**Finalised Development Framework for
the Maddiston East Strategic
Growth Area**

Falkirk Council

Title: Finalised Development Framework for the Maddiston East Strategic Growth Area
Meeting: Executive
Date: 29 November 2016
Submitted By: Director of Development Services

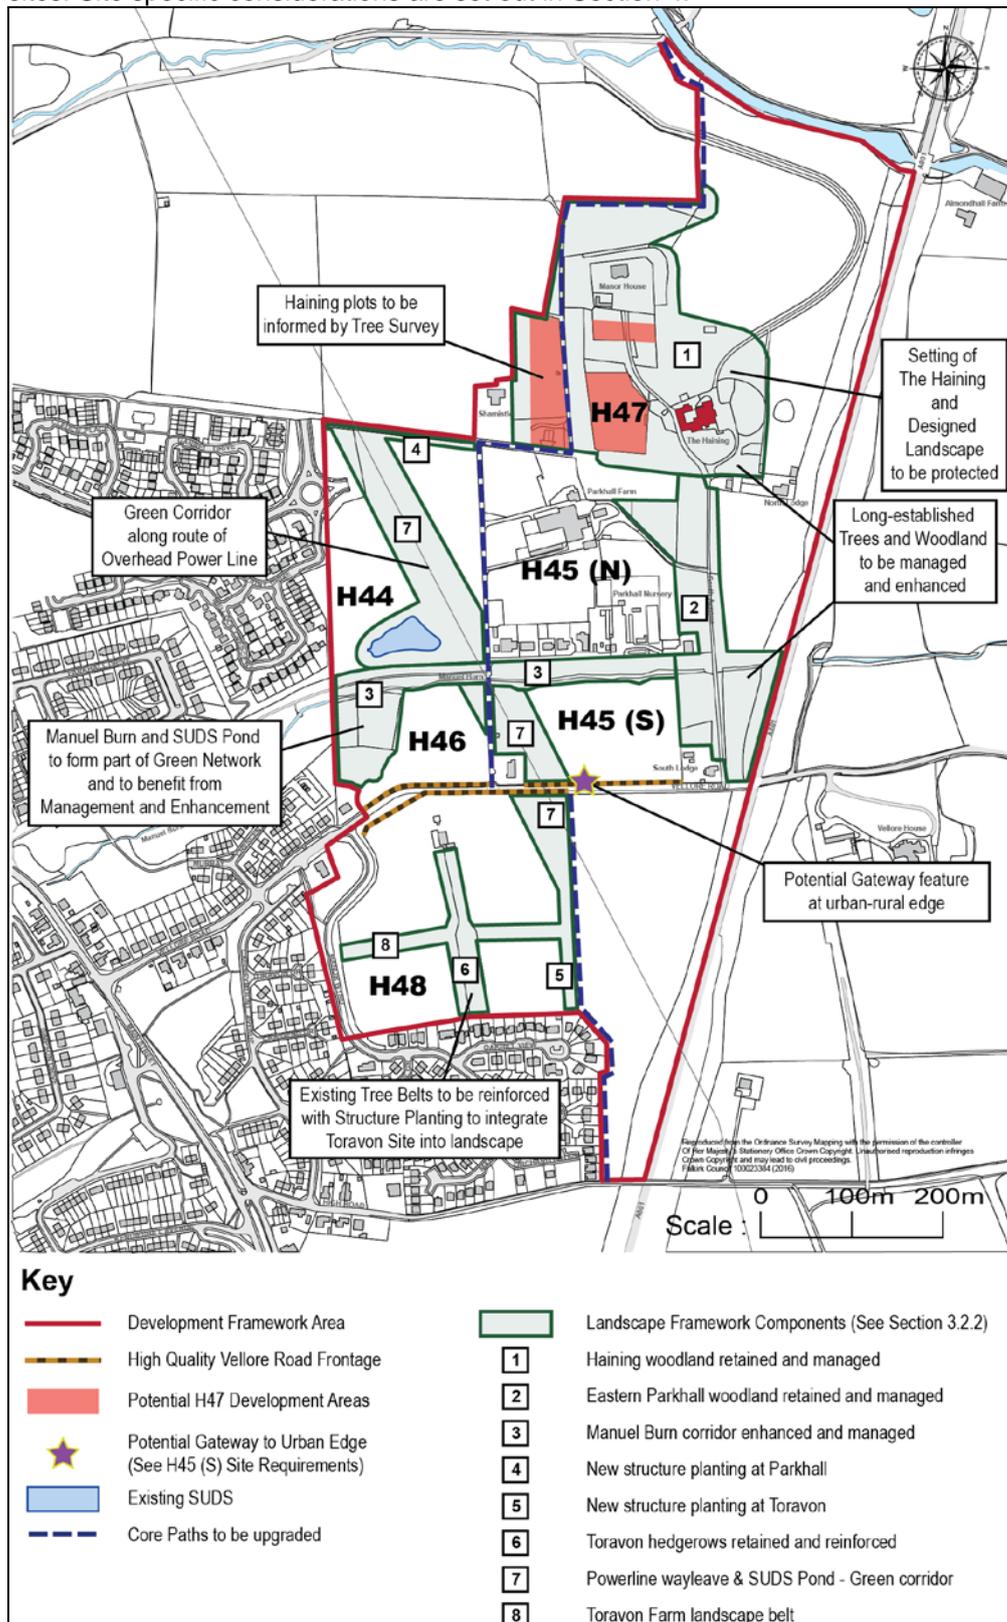
<p>The Development Framework Plan presented in Map 5 shows key features and interventions. We recommend that</p>	<p>Proposed response: The Falkirk Green Network is a policy provision of the Falkirk LDP and is shown on Map 1. The aims of the Green</p>

the final version also includes the two green network proposals GN16 and GN18.	Network are adequately reflected in the Development Framework Plan (Map 5). Proposed Change: None.
Manor Forrest Ltd	Welcomes approach to green network but advises that Development Framework should be modified. The Council will need to carefully consider how the SINC corridor will be safeguarded in relation to a burn crossing. Tree planting along northern boundary is not achievable as track to north is outwith Manor Forrest control. A green corridor linking landscape components 3 and 5 does not have geographical or visual linkage.	Proposed response: Any new burn crossing will be designed so as to allow a riparian corridor to remain. Tree planting along the northern boundary can be implemented on land to the south of the track. Landscape components 3 and 5 are the burn corridor and eastern structure planting within Toravon Farm. They are linked by virtue of the overhead line (component 7) which will be open space. Proposed change: None.

Owners of Parkhall Nursery (represented by Montagu Evans LLP)	The respondent does not support the inclusion of play provision in H45(N). This would be best located elsewhere.	Proposed response: Following on from the adoption of the Council’s Open Space Strategy, the accessibility requirements for proximity to play provision are now 800m. Almost all of the Development Framework area now falls within this accessibility threshold.

<p>Proposed change: Amend Map 5 Development Framework Plan to delete requirement for play provision.</p> <p>Replace para 3.2.7 with “ <i>Passive open space will be incorporated within each of the development sites. The main focus for active open space such as equipped play areas and sports pitches will be on improvements to off-site facilities though developer contributions.</i>”</p> <p>Delete requirement for on-site play provision in site requirements for H45(N) and H48.</p>
	The respondent wished to oppose the 10m buffer along the Manuel Burn corridor on the basis that there are already existing properties within this distance and that the burn is of limited ecological value.	<p>Proposed response: The burn corridor is a locally-designated ecological site (Site of Importance for Nature Conservation) and part of the Falkirk Green Network. As such the land requires to be protected from development, and managed/enhanced in conjunction with the SGA sites.</p> <p>Proposed change: None.</p>

MAP 6: Preferred Access Option

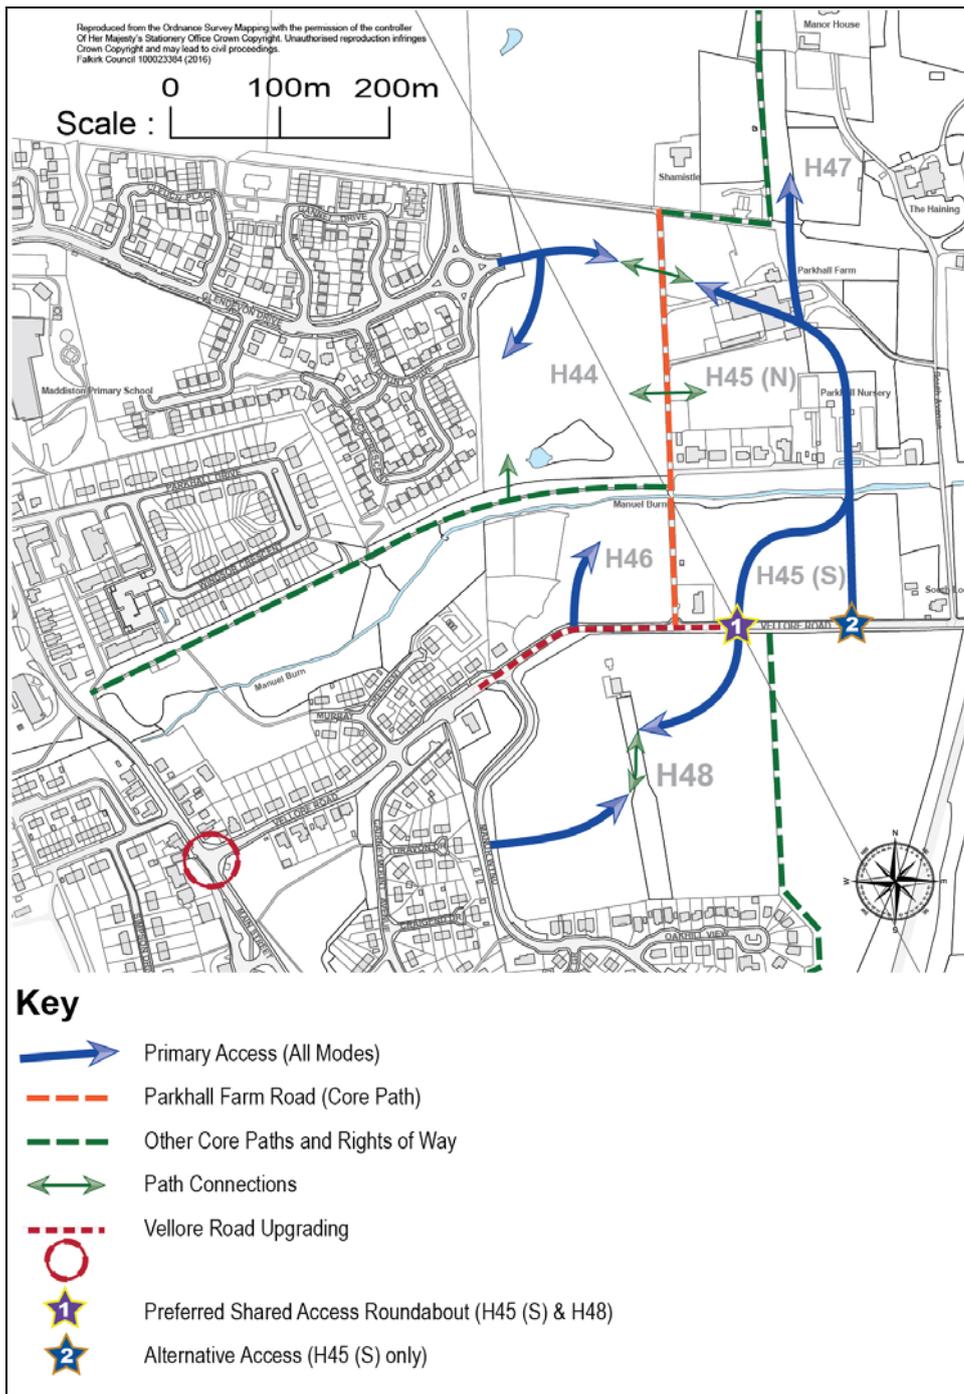
Respondent	Comment	Proposed response
ISSUE: Access options		
Maddiston Community Council	Maddiston Community Council does not consider Access Option 1 to be viable as it would require a major upgrade of Vellore Road. Vellore Road is also unlit, and there is no pavement so cyclists and pedestrians which currently use the road would be affected.	<p>Proposed response: Option 1 has been considered and will not be taken forward as a preferred option.</p> <p>Proposed change: Take forward Option 4 in Development Framework.</p>
	Maddiston Community Council does not consider Option 2 to be suitable as Nicolton Road is narrow and restricted, and an upgrade would be costly.	<p>Proposed response: Option 2 has been considered and will not be taken forward as a preferred option.</p> <p>Proposed change: Take forward Option 4 in Development Framework.</p>
	Maddiston Community Council does not support Option 3 to link Glendevon Drive to the A801 due to road safety issues (particularly around the school which is congested at peak times) associated with Glendevon Drive becoming a through-route.	<p>Proposed response: Option 3 has been considered and will not be taken forward as a preferred option.</p> <p>Proposed change: Take forward Option 4 in Development Framework.</p>

Maddiston Community Council considers option 4 to have the least impact on the local community. They also suggest linking northwards through H47 to the A801, if a link was required, rather than using Glendevon Drive.	<p>Proposed response: Option 4 is the Council's preferred option. No link to the A801 is proposed as part of the Development Framework.</p> <p>Proposed change: Take forward Option 4 in Development Framework.</p>
	The Community Council has concerns that these developments are designed only for people with cars and	<p>Proposed response: The sites are currently-allocated LDP sites and the principle of development of the sites is already established</p>

Resident of Glendevon Drive, Maddiston	Respondent would resist a link to A801 on road safety grounds. The road would become a main access route and would result in a significant increase in traffic. They would also resist using Glendevon Drive for any other development and building traffic resulting from new development has already resulted in noise and disruption.	Proposed response: Option 4 is the Council's preferred option. Development viability and proportionality, as well as fit with the LDP and impacts on the landscape and natural heritage were all factors taken into consideration when arriving at an option. Road safety issues and any possible mitigation will require to be addressed as part of the delivery of new sites. Glendevon Drive will be the sole access for H44. Proposed change: Take forward Option 4 in Development Framework.
Resident of Gannel Drive, Maddiston	Would prefer Access Option 4 as it limits the traffic on Glendevon Drive. Expresses concerns around road safety at the primary school.	Proposed response: Option 4 is the Council's preferred option. Road safety and capacity of the network was a consideration when arriving at an option. Glendevon Drive will be the sole access for H44. Proposed change: Take forward Option 4 in Development Framework.

Resident of Cleuch Place, Maddiston	Resident strongly opposed options 1, 2 and 3. They would prefer Access Option 4 as it limits the traffic on Glendevon Drive. Expresses concerns around road safety at the primary	Proposed response: Option 4 is the Council's preferred option. Road safety and capacity of the network was a consideration when arriving at an option. Glendevon Drive will be the sole access for

school.	H44. Proposed change: Take forward Option 4 in Development Framework.
Resident of Gannel Drive, Maddiston	Would not support A801 link. Would favour routes utilising Vellore Road.	Proposed response: Option 4 is the Council's preferred option. Road safety and capacity of the network was a consideration when arriving at the preferred option. Proposed change: Take forward Option 4 in Development Framework.
Owners of Parkhall Nursery (represented by Montagu Evans LLP)	The respondent wishes to express support for Access Option 1. This option would provide effective access for H45(N). Options 2 and 3 would involve an unsustainable level of cost, and are outwith the development envelope.	Proposed response: Option 4 is the Council's preferred option. Development viability and proportionality was a factor taken into consideration when arriving at the preferred option. Proposed change: Take forward Option 4 in Development Framework.

Scottish Natural Heritage	Option 3 should be scoped out of further consideration unless it can be demonstrated that these potential effects on ancient and semi-natural woodland could be avoided.	Proposed response: Comments noted. Option 4 is the Council’s preferred option. Development viability and proportionality, as well as fit with the LDP and impacts on the landscape and natural heritage were all factors taken into consideration when arriving at the preferred option. Proposed change: Take forward Option 4 in Development Framework.

<p>While Option 2 avoids the landscape impacts that would arise from the ridge, the new urban edge that would be created through creating the connection to Nicolton Road would likely change the character of this edge. It seems likely that the creation of a distributor road connecting to Nicolton Road would also lead to further development within that new edge.</p>	<p>Proposed response: Comments noted. Option 4 is the Council's preferred option. Development viability and proportionality, as well as fit with the LDP and impacts on the landscape and natural heritage were all factors taken into consideration when arriving at the preferred option.</p> <p>Proposed change: Take forward Option 4 in Development Framework.</p>
	<p>Option 1 and 4 are also described as likely to include "some loss" of ancient and semi-natural woodland. Our advice at this stage is that the extent of this loss would need to be more clearly defined before the acceptability of these options can be confirmed. However, based on the current information, we consider Option 1b as least likely to lead to significant impacts.</p>	<p>Proposed response: Comments noted. Option 4 is the Council's preferred option. Development viability and proportionality, as well as fit with the LDP and impacts on the landscape and natural heritage were all factors taken into consideration when arriving at an option.</p> <p>Proposed change: Take forward Option 4 in Development Framework.</p>

3.3.4 The Council's preferred access option is Option 4 (as shown in Map 6). Sites would generally have their own individual vehicular accesses (with the exception of H47, which would be accessed by means of a continuation of the H45 access route).
